THE CAROLINA GROUP - WORTHINGTON
 CHARLOTTE, NC

ATTACHMENT A - RESOLUTIONAL

FOR PUBLIC HEARING
 REZONING PETITION
 #2010-031

SUBJECT: Administrative Approval for Petition No. 2010-031 The Carolina Group

RZ1.0

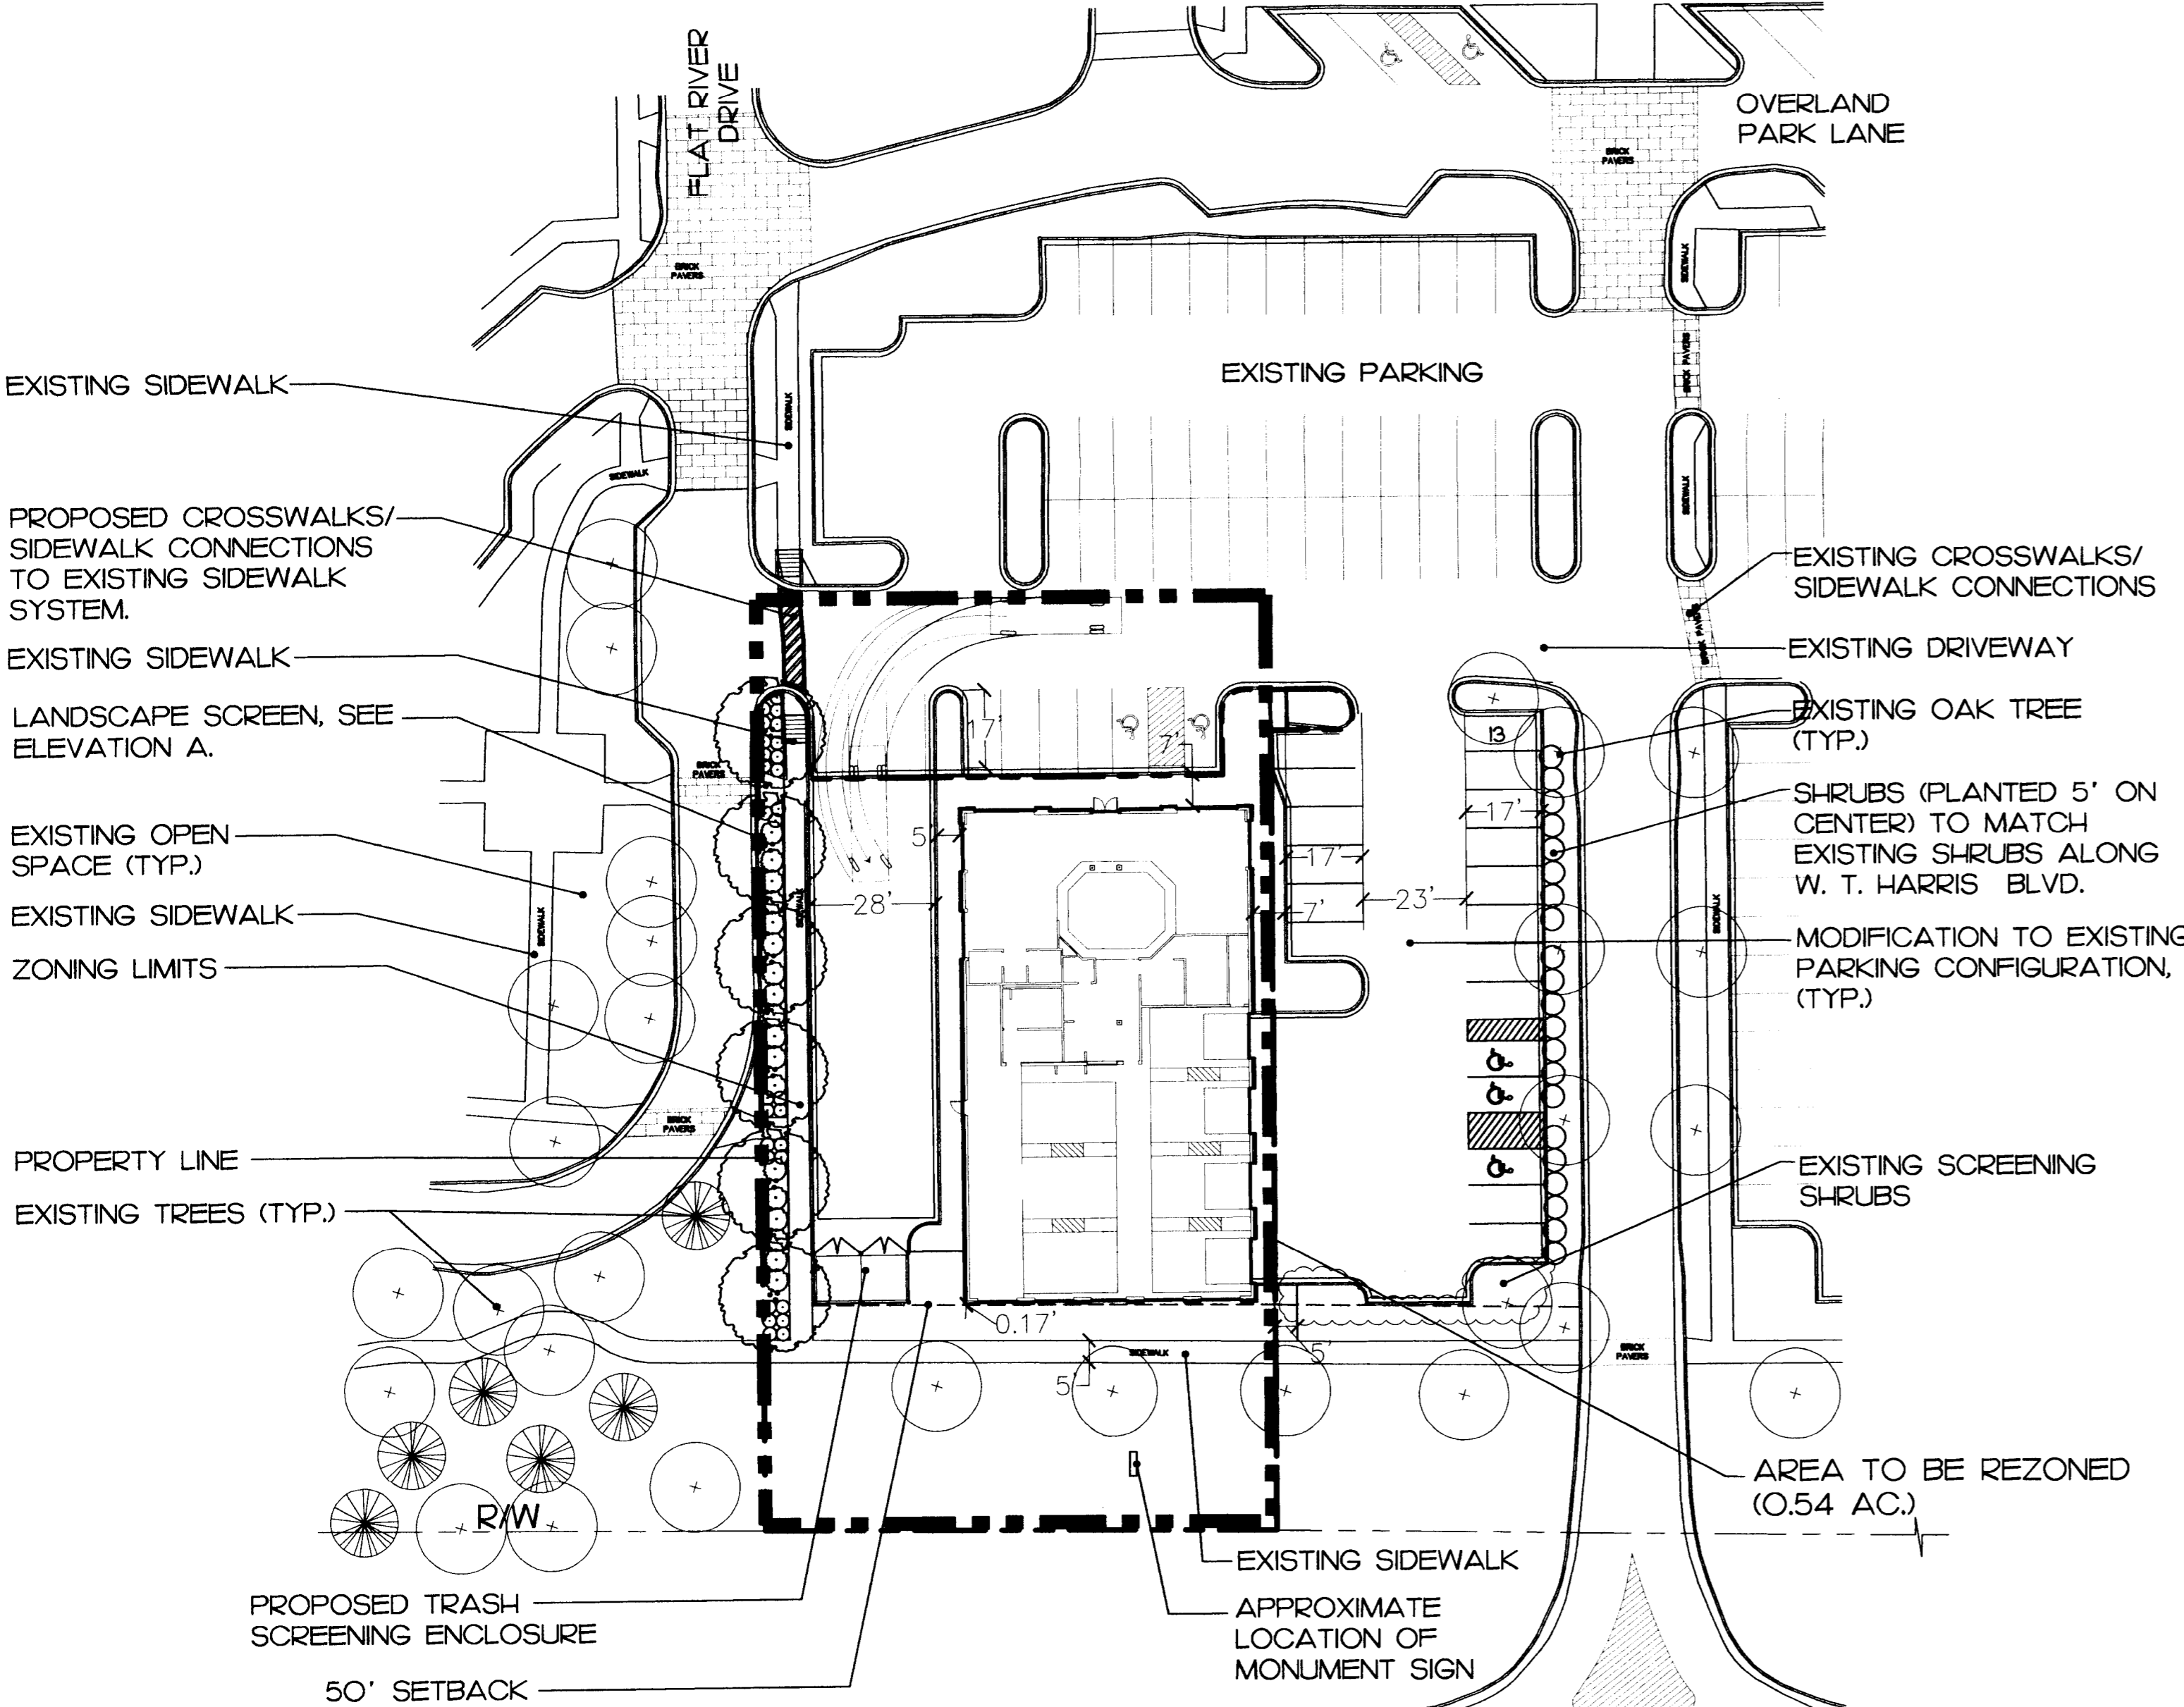
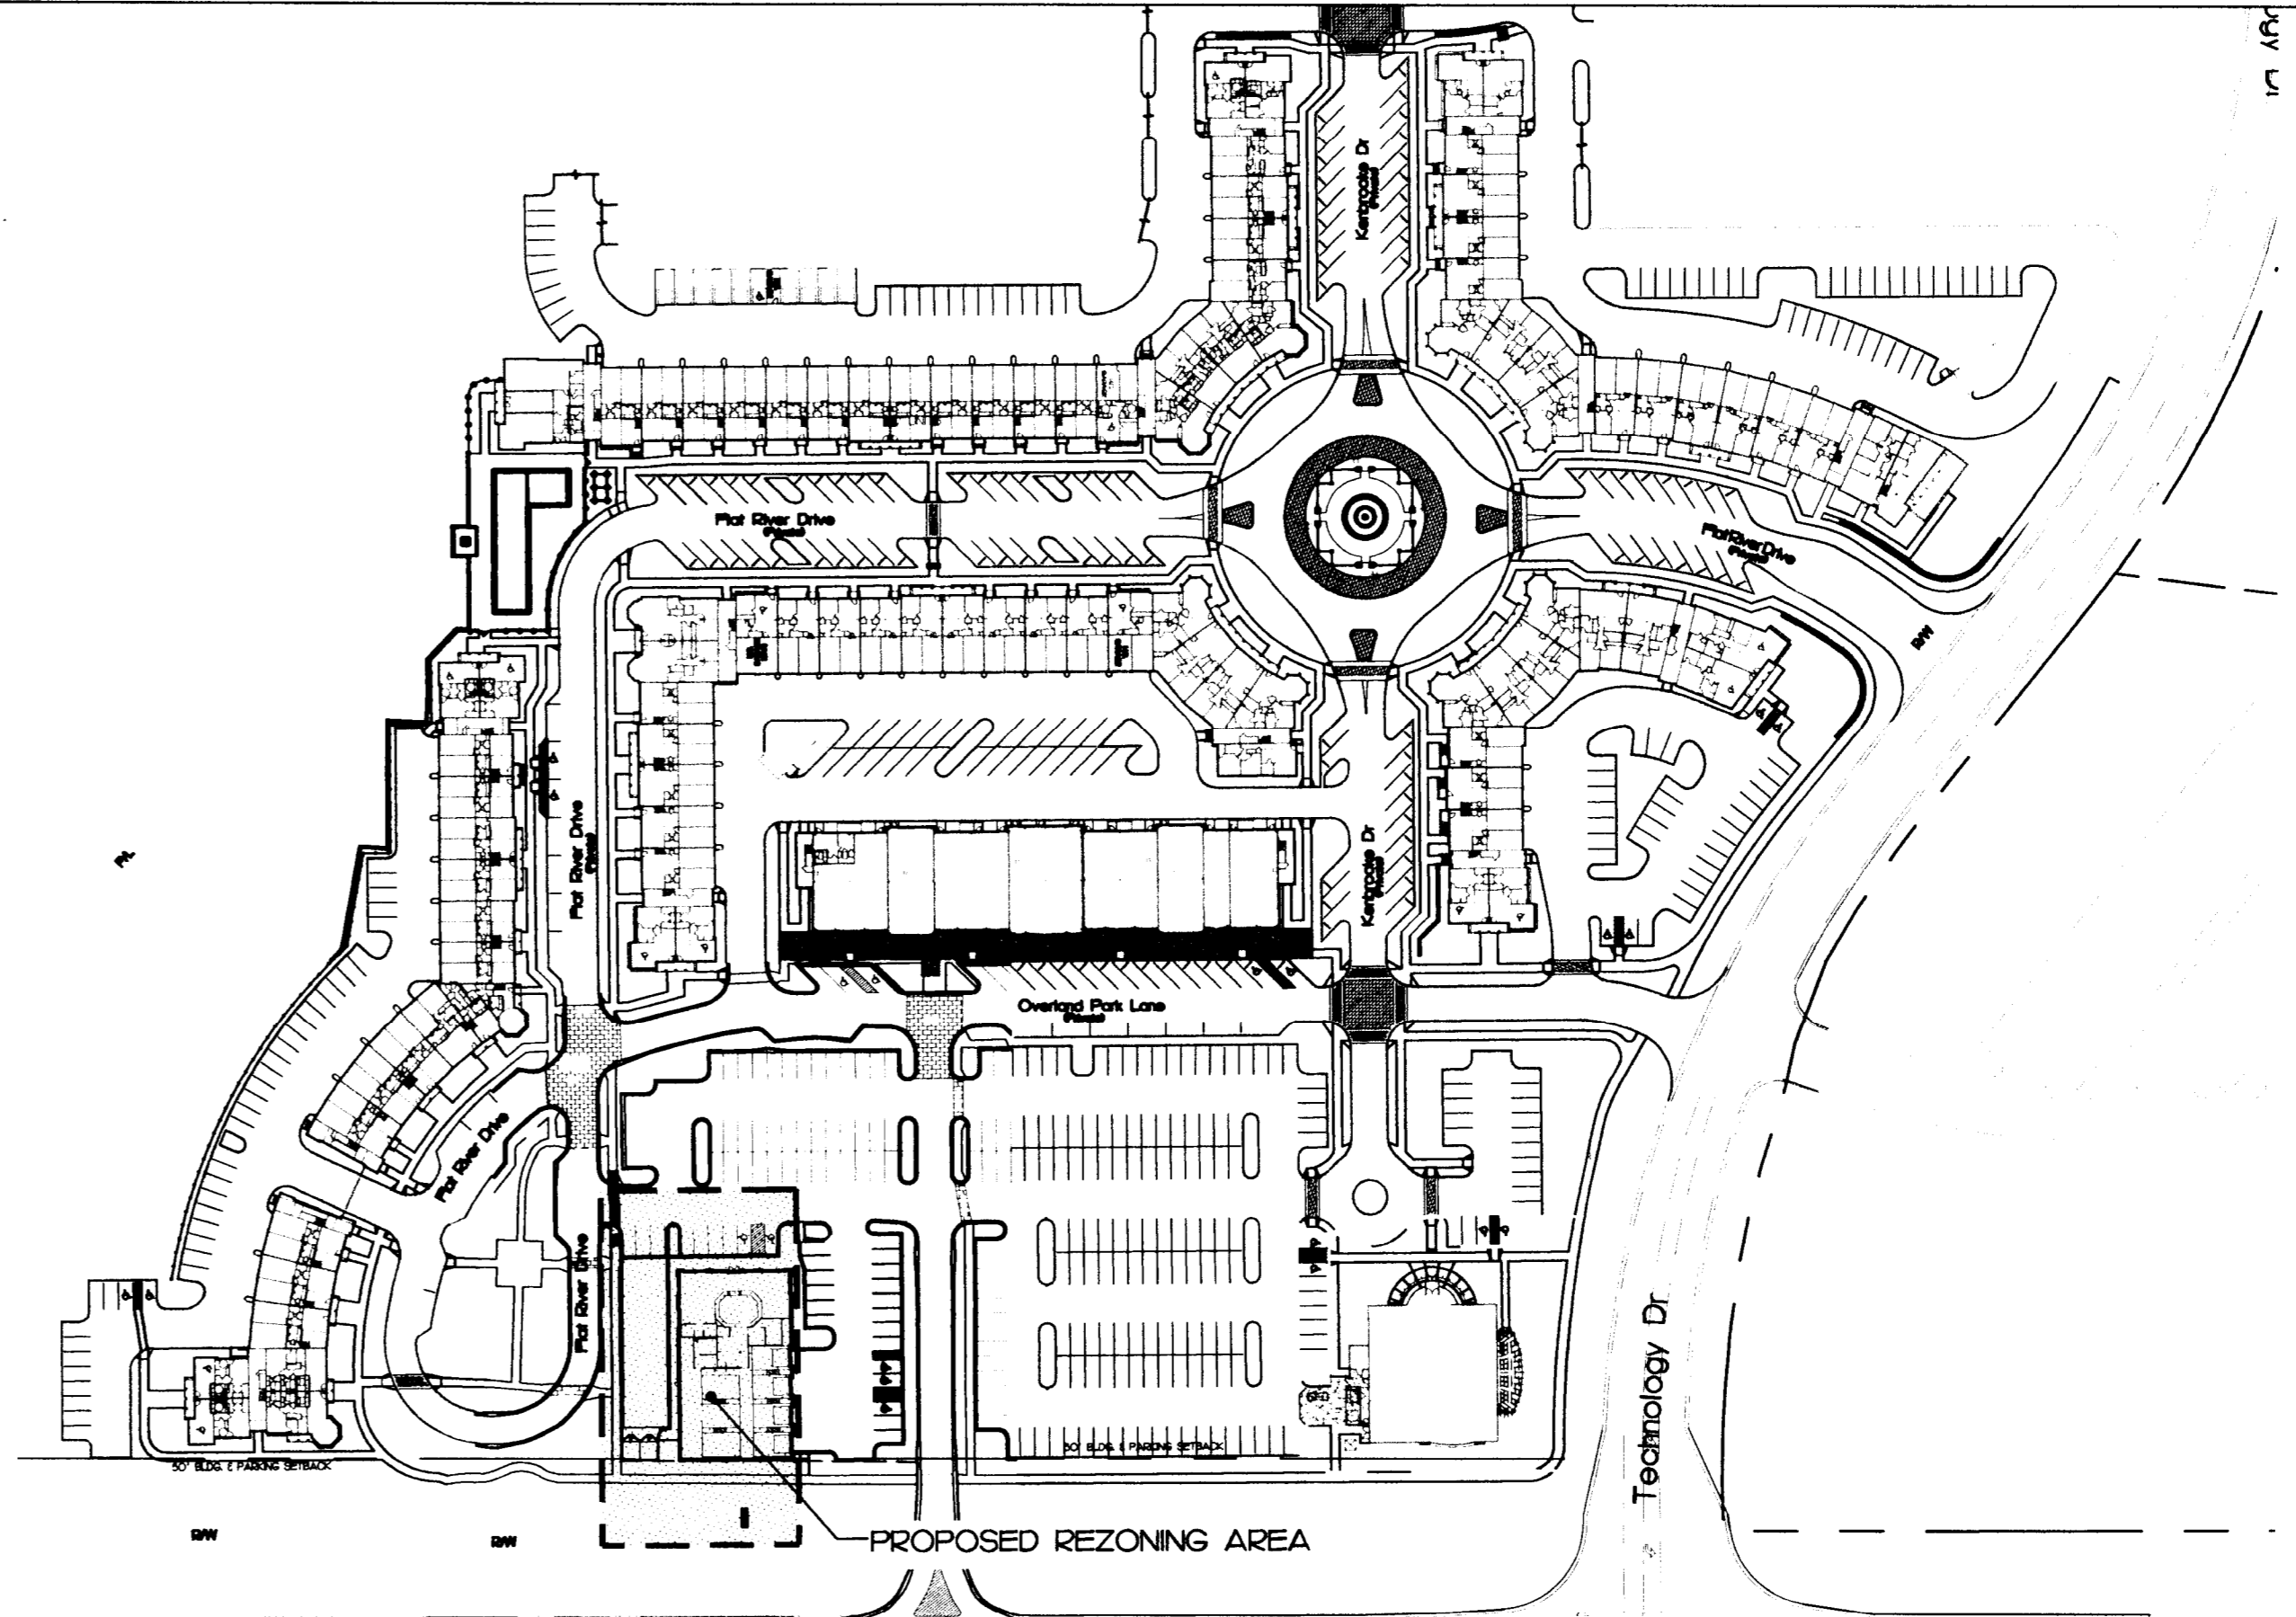
Attached are revised plans for the above petition. The plans have been revised to make minor changes to allow the building footprint to shrink but maintain the approved square footage. Since these changes are minor and do not alter the intent of the development and meet the requirements of the Charlotte Zoning Ordinance Section 6.207 Alterations to Approval, minor changes, I am administratively approving these plans. Please use these plans when evaluating requests for building permits and certificates of occupancy.
